VSP-30  
May 20, 1981

VENDOR SERVICE PUBLICATION

Subject: Bendix Service Bulletins 599A, 609A, 610,  
613, 614

**SERVICE BULLETIN NO. 599A**  
(Supersedes Service Bulletin No. 599)  
Engineering Aspects are  
FAA Approved

Figure 1.

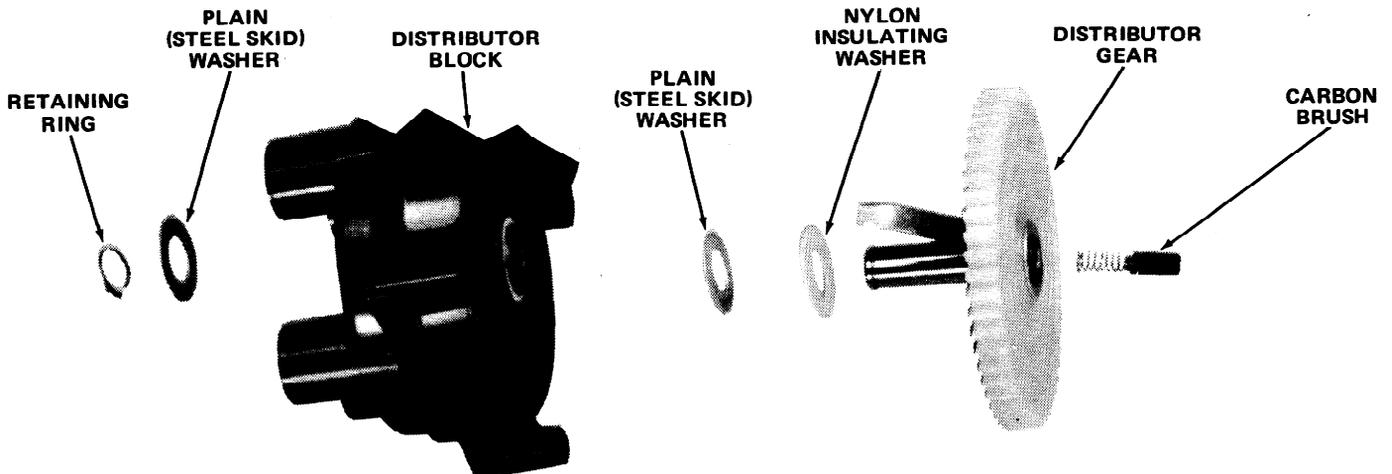
**REASON FOR BULLETIN:** To announce availability of an improved insulated distributor gear (kit) for the subject magnetos.

This bulletin announces availability of an improved, insulated distributor gear in kit form which is interchangeable between the D-2000/D-2200 & D-3000/D-3200 series magnetos. The kit includes all parts (except distributor block) as identified in figure 1.

Assembly sequence of the gear kit to distributor block is shown in Figure 1.

When timing magneto on bench or when re-installing magneto on engine, no gear holding timing device should be used as hidden gear tooth damage may result.

Figure 1. Location of Identification Mark

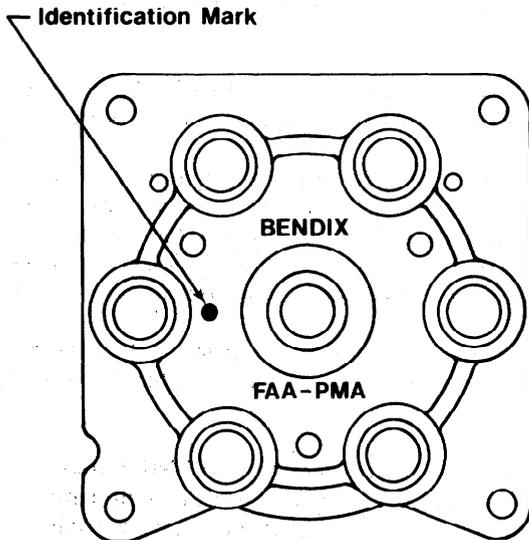
1. To announce the availability of an improved Diallyl Phthalate (DAP) green distributor block incorporating a new design "Gripper" oilite bushing.
2. To alert users of a possible loose oilite bushing in the original green DAP distributor block. Field reports indicate that the bronze oilite bushing in the current green distributor block may become loose and turn within the block. This condition could wear the block enough to cause the distributor gear to become mistimed resulting in rough engine operation.
3. To provide instructions for inspection and/or replacement of the original green distributor blocks with the new "Gripper Bushing" green distributor blocks as required.

The new "Gripper Bushing" will eliminate the possibility of the bushing becoming loose. The "Gripper Bushing" block can be identified by a circular shaped mark 0.188 inch  $\pm$  0.031 inch in diameter raised 0.010 inch to 0.030 inch above the surface of the block. This mark is located on the tower side of the block, as indicated in figure 1.

Figure 6. Distributor Gear/Block Exploded View

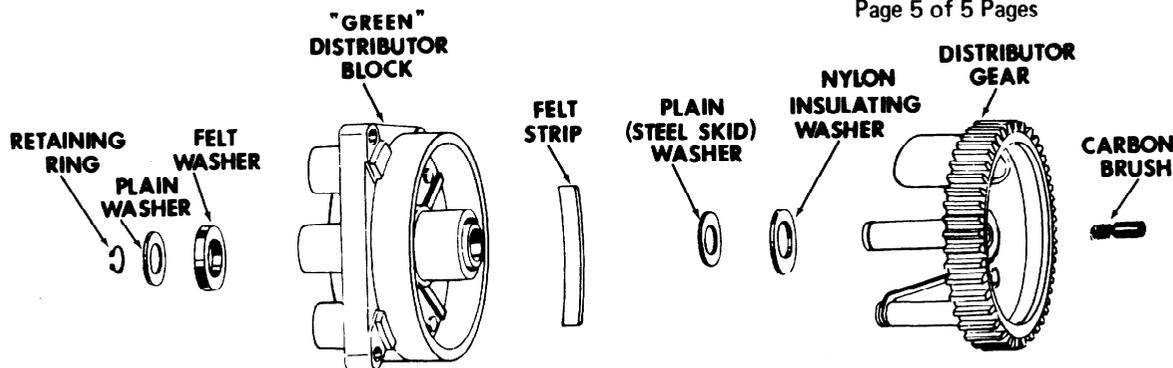
8. For reassembly, reference figure 6 and proceed as follows:

It is no longer necessary to lubricate the gear axle during assembly, as the distributor block bushing is impregnated with a lubricant during the manufacturing process.

d. Remove the "Gripper Bushing" distributor block and re-lubricate if necessary with Bendix Distributor Block Lubricant, P/N 10-391200.

e. Install the felt washer, P/N 10-50752, in the block and re-lubricate if necessary with Bendix Distributor Block Lubricant, P/N 10-391200.

Figure 1 Defect

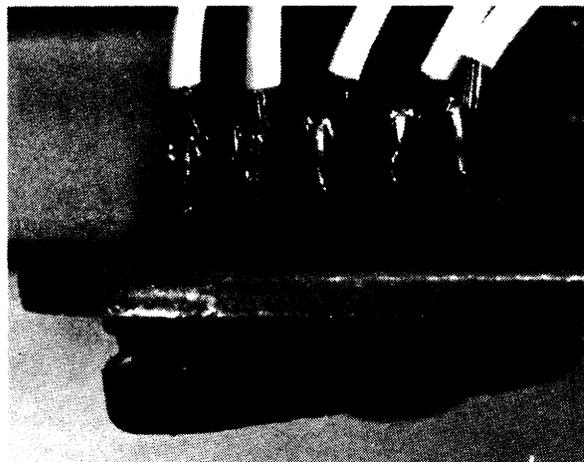
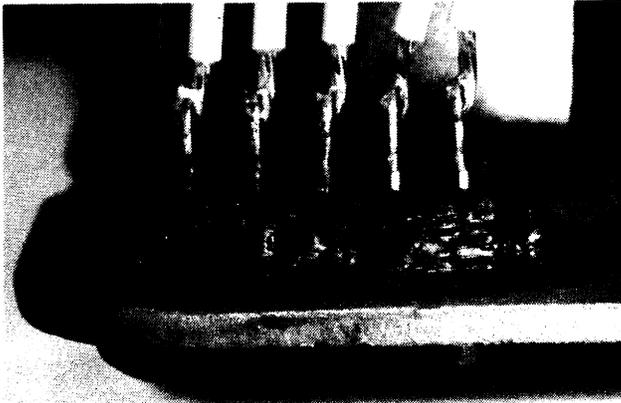
Bushing (connector), P/N 10-382943, may become loose in the vibrator plate and cause the grounding of both magnetos with possible loss of ignition. See figure 1 (defect).

1. Remove starting vibrator from the airframe.
2. Remove cover to expose the internal surface of the terminal bushing (connector).
3. The surface around the terminal bushing must be clean, dry, free of oil, dirt and grease.
4. Reseat the terminal bushing in the mounting plate to its full extent.

5. Use RTV (Silicone rubber sealant, or equivalent, Dow Corning Corp., Midland, Mich. 48640) to seal terminal bushing to the mounting plate. Apply a small bead completely around the bottom of bushing to secure the bushing to the plate as shown in figure 2 (repaired). If RTV is not available, use either Hysol, Epoxi-Patch Kit (general purpose), Hysol Corp., Olean, NY or Conap, Easyoxy Kit (K20 general purpose) 1405 Buffalo St., Olean, NY, or equivalent.
